AGENDA

President and Board of Trustees
Village of Arlington Heights
Board Room
Arlington Heights Village Hall
33 S. Arlington Heights Road
Arlington Heights, IL 60005
October 17, 2016
8:00 PM

Mr. Sam Hubbard
PC Project #16-020
STR Project # 16047
September 21, 2016
Page 10 of 10

THOMAS MIDDLE SCHOOL ADDITION AND RENOVATIONS

C1.1

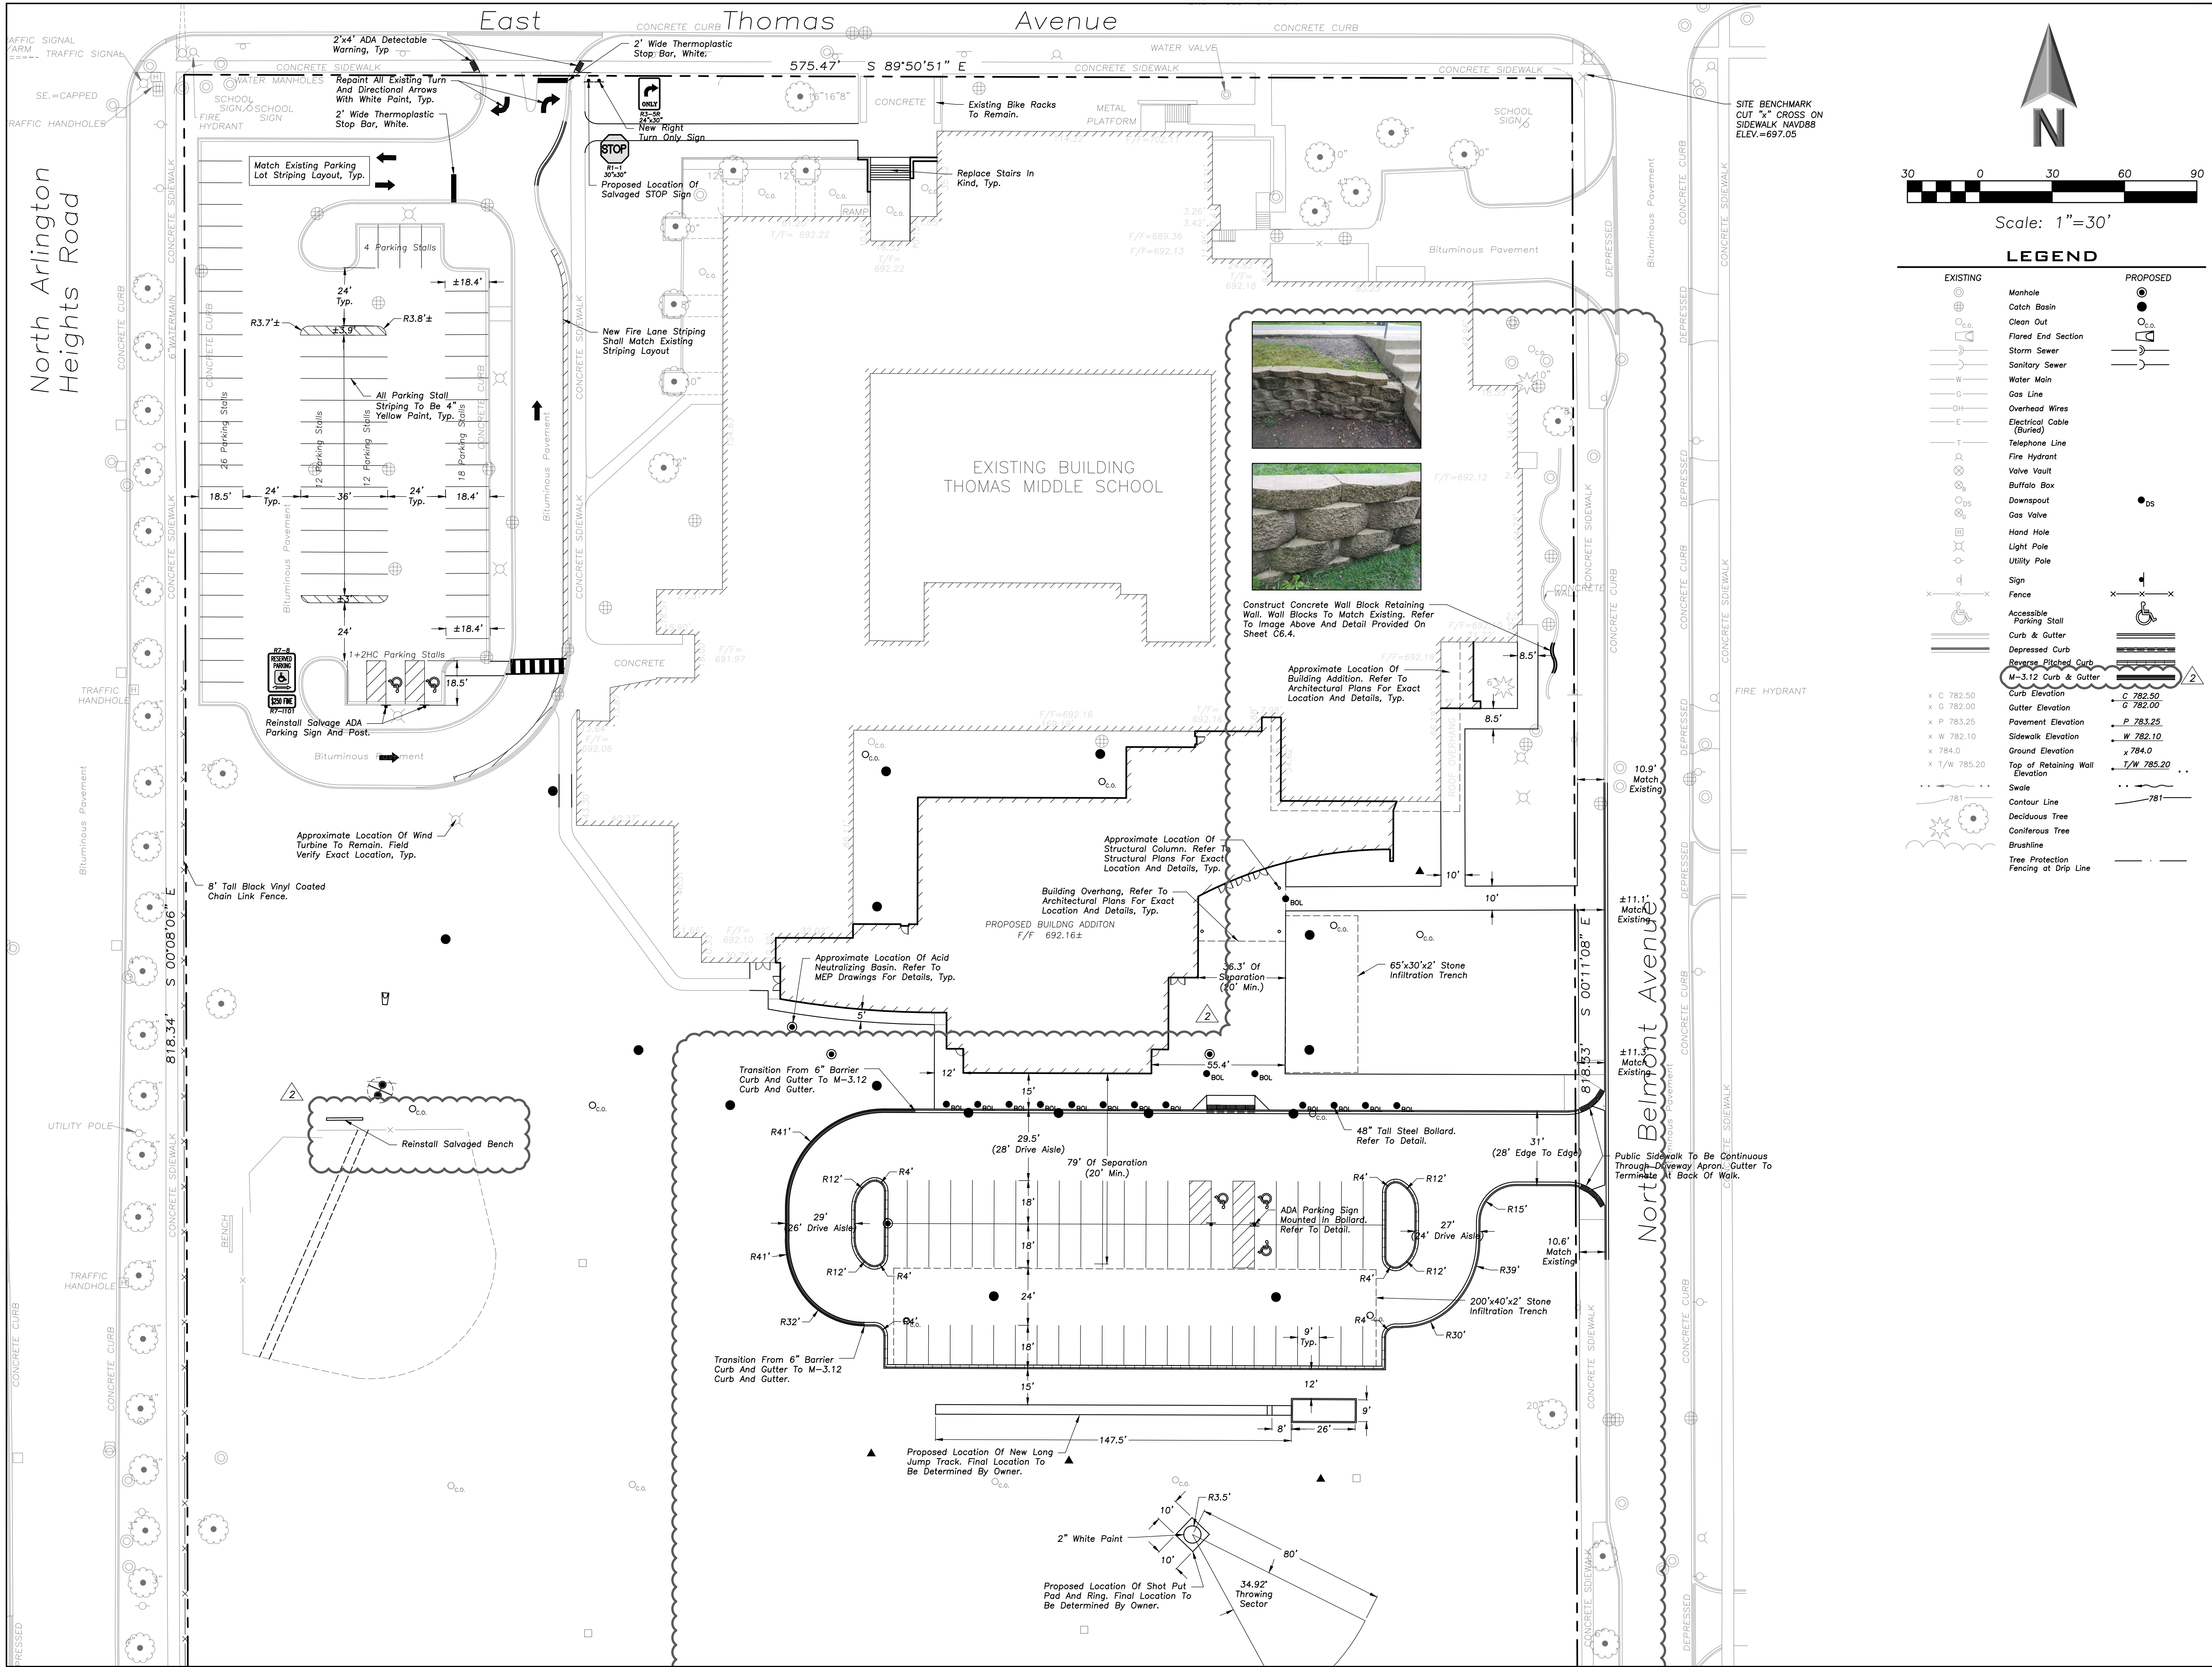
18. Sheet C1.1: There is an area northwest of the building that is shown as to be removed plan, but is not addressed anywhere else in the plans. Is this included in the project?

A note has been added to Sheet C1.1 calling for the condition of any traffic signage to be verified in compliance with MUTCD requirements prior to reuse.

C3.1

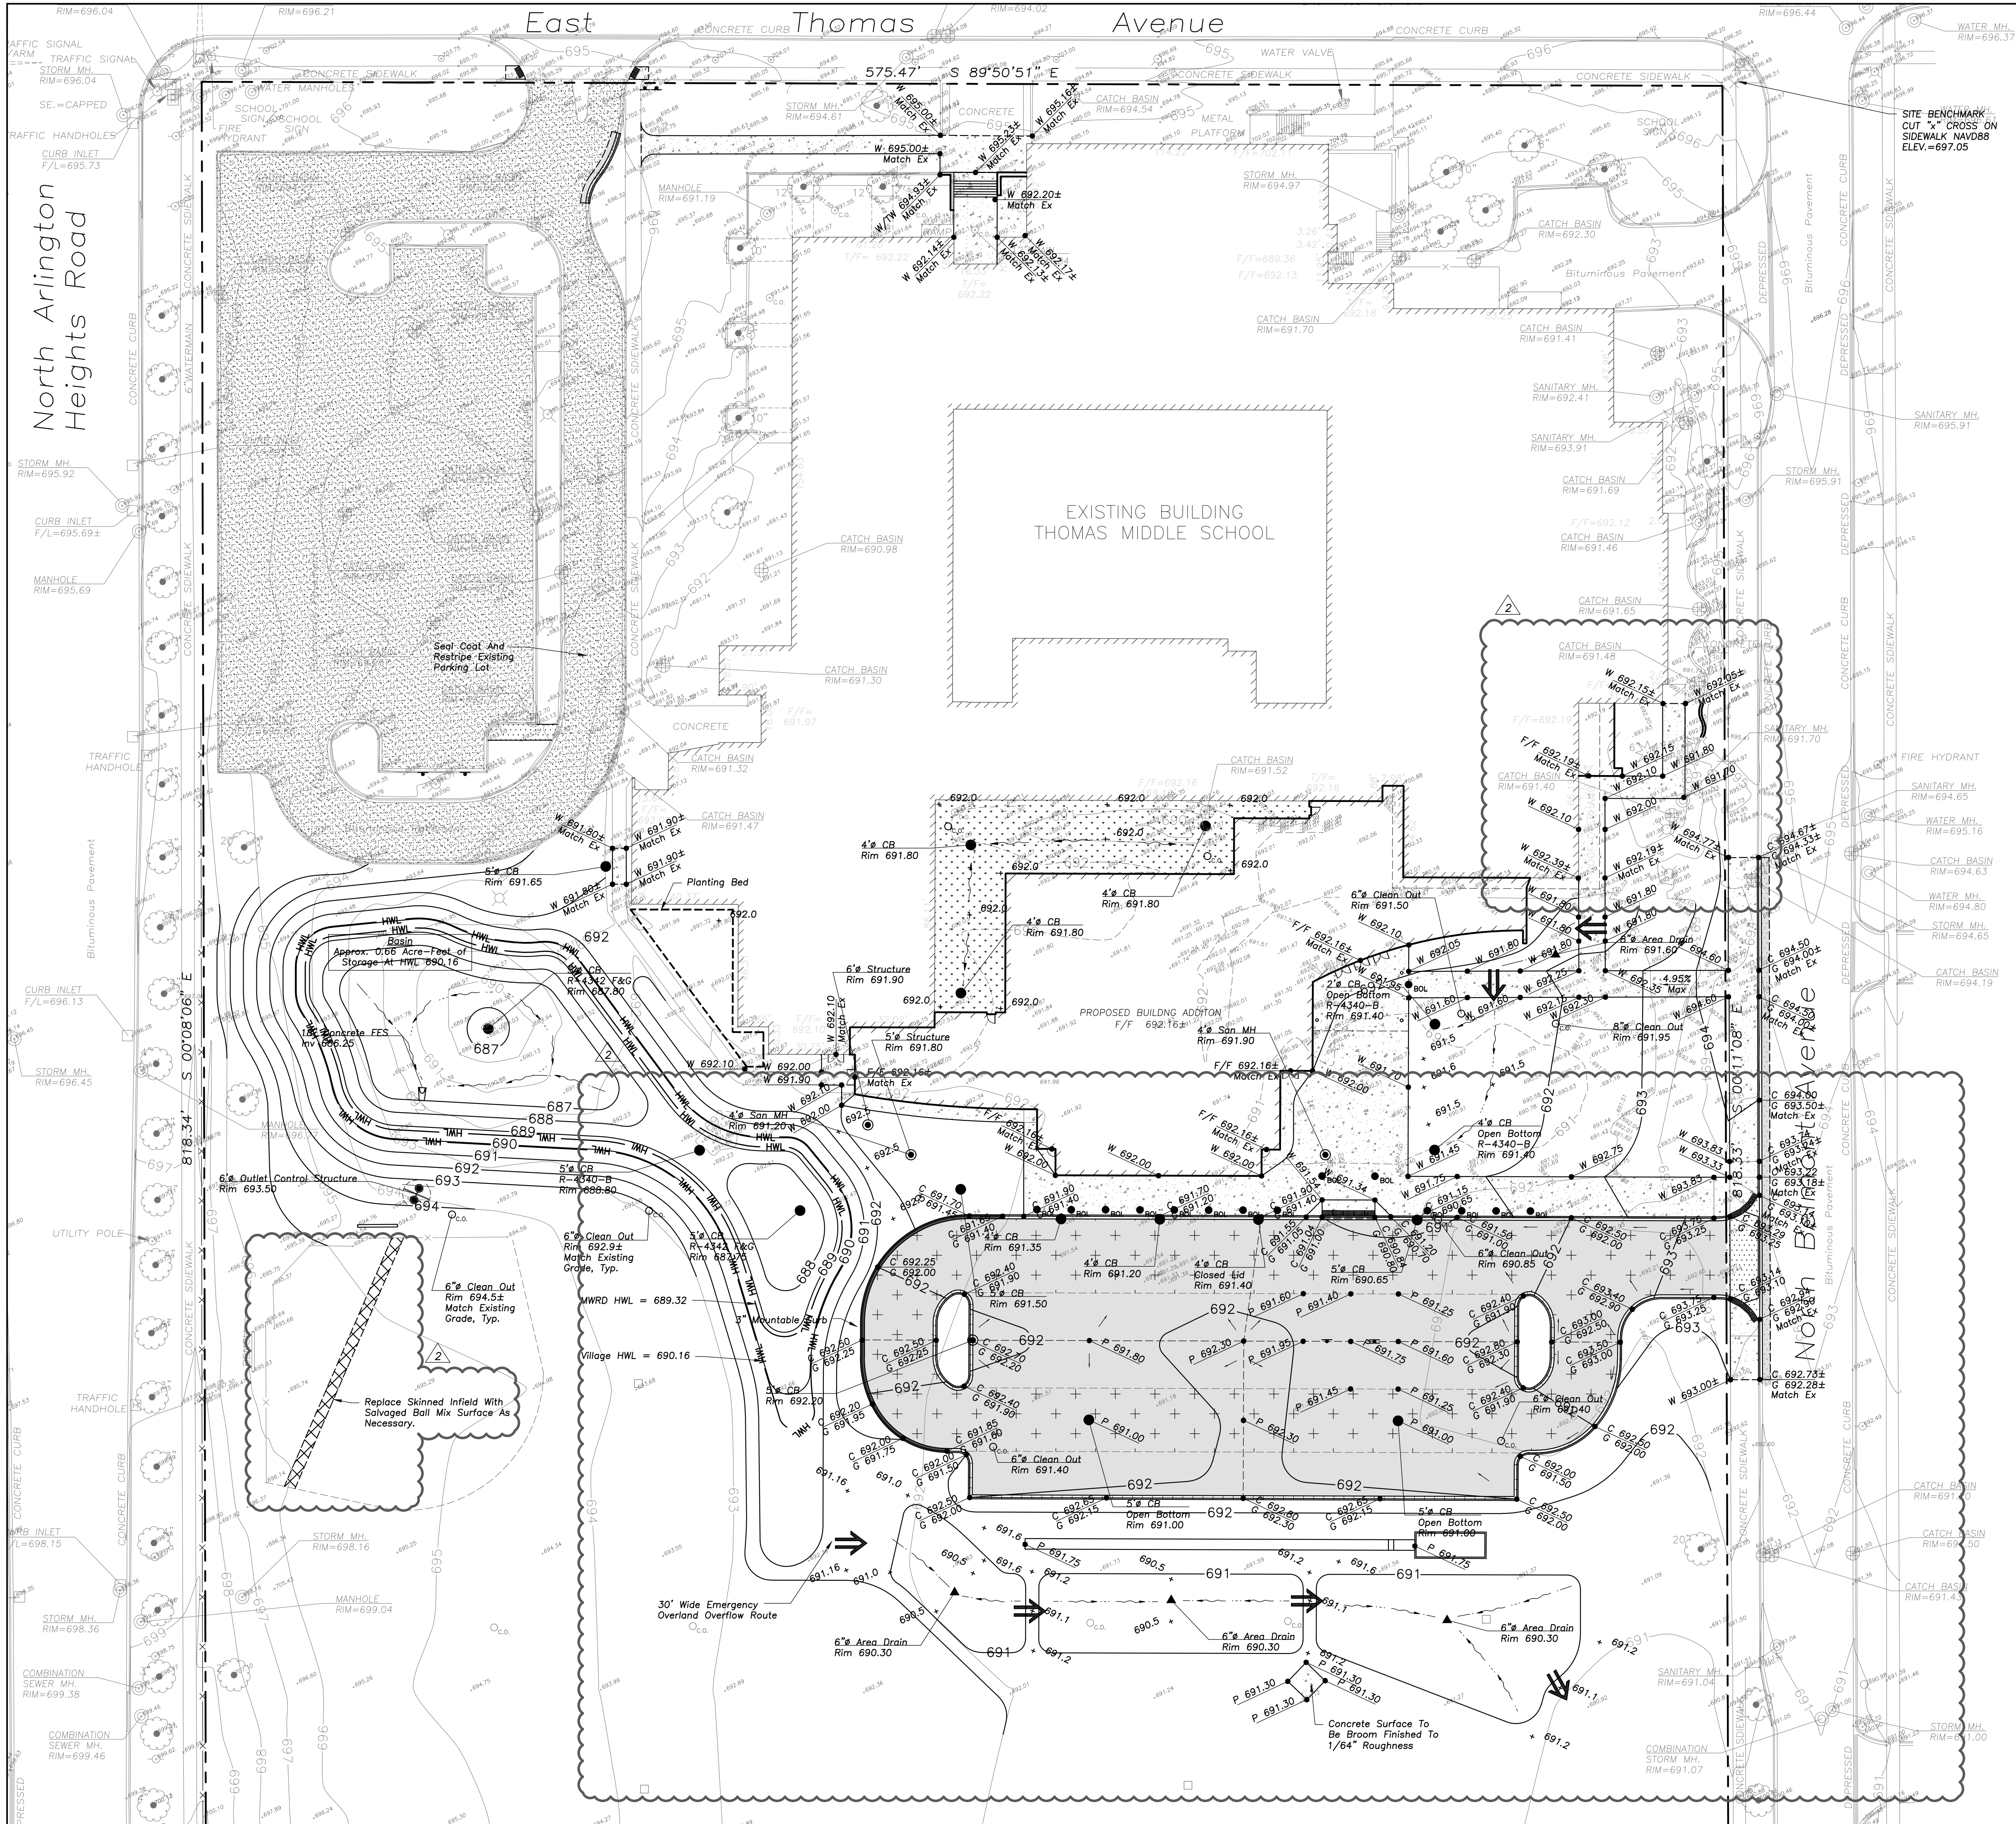
19. Sheet C3.1: There is an existing north-south 6" PVC sewer line shown per the record drawing south of the new building addition. This existence and function of this line must be verified prior to approval.

The existence of the PVC storm sewer shall be investigated. Upon an initial site visit the structures shown on the record plan were not located. Notes calling to field locate and verify the 6" storm sewer has been added to Sheet C3.1.

C4.1

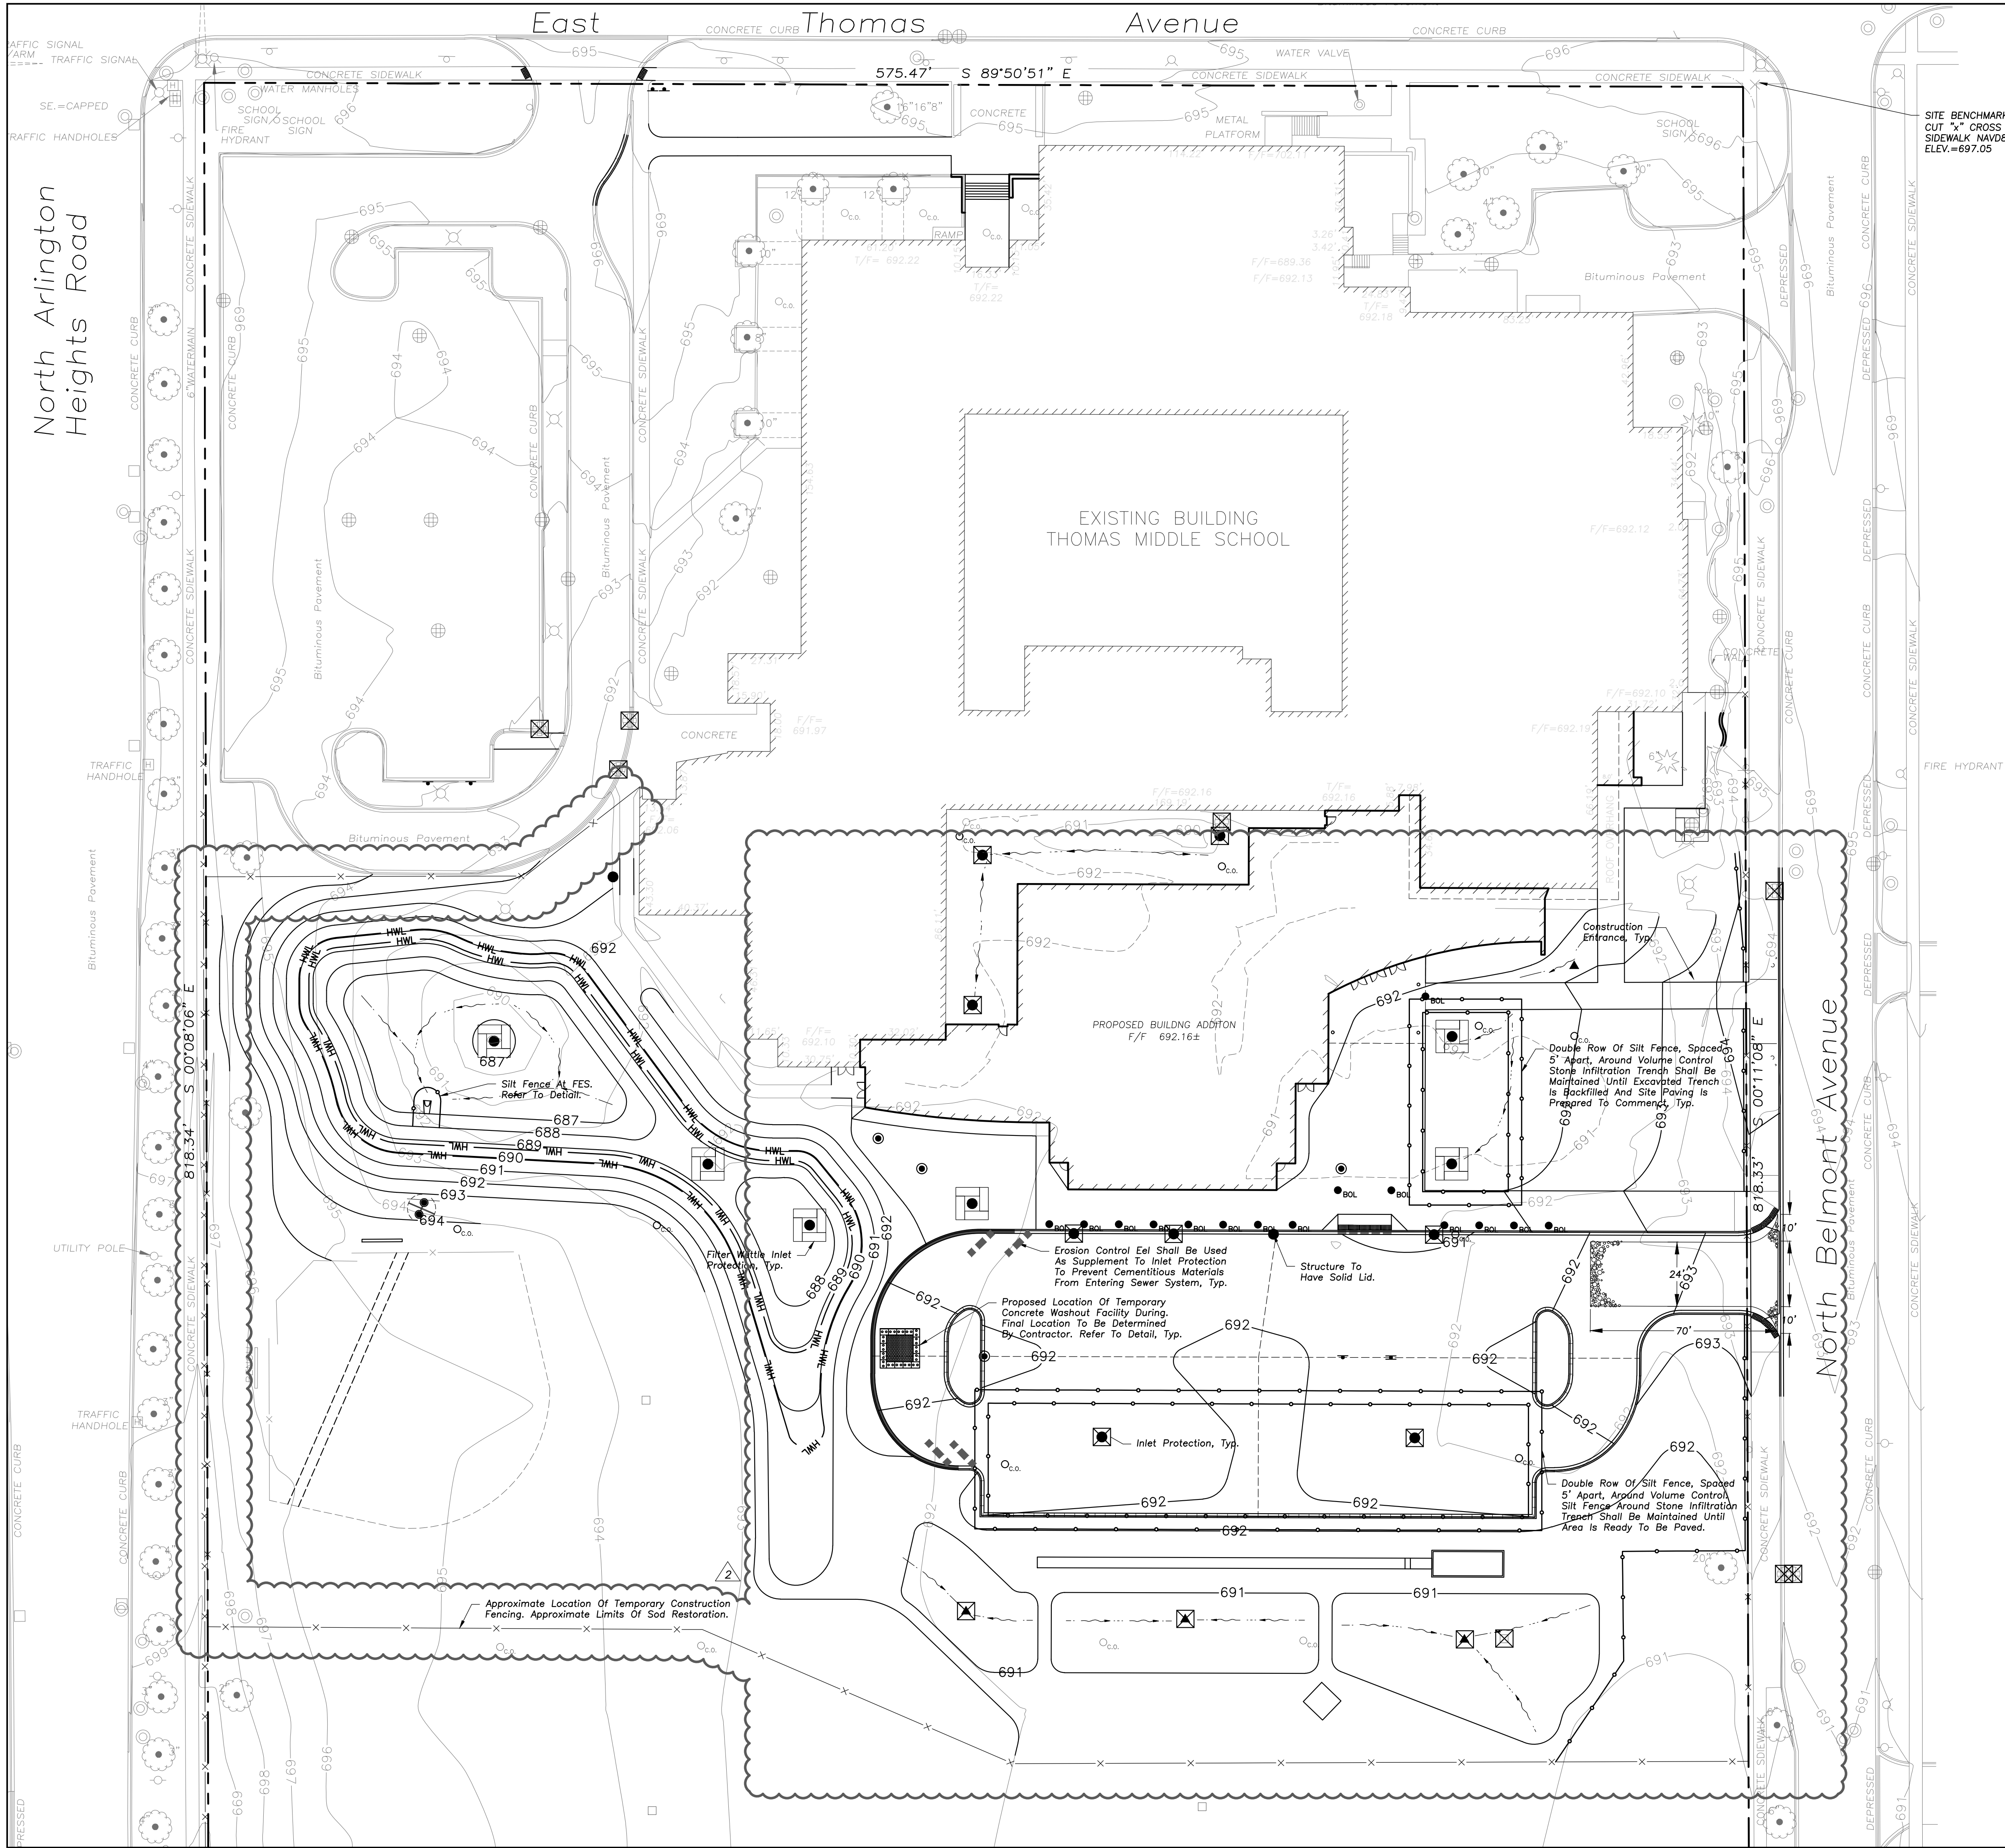
20. Sheet C4.1: The HWL in the east pond is shown at elev. =689.16, not at the actual HWL of 690.16. Double check detention calculations.

The Heavy-Duty (Fire Lane) Asphalt Pavement Section shown in the Paving & Surface Legend on Sheet C4.1 has been revised. Notes to omit the welded wire fabric in the public ROW have also been added to the legend.
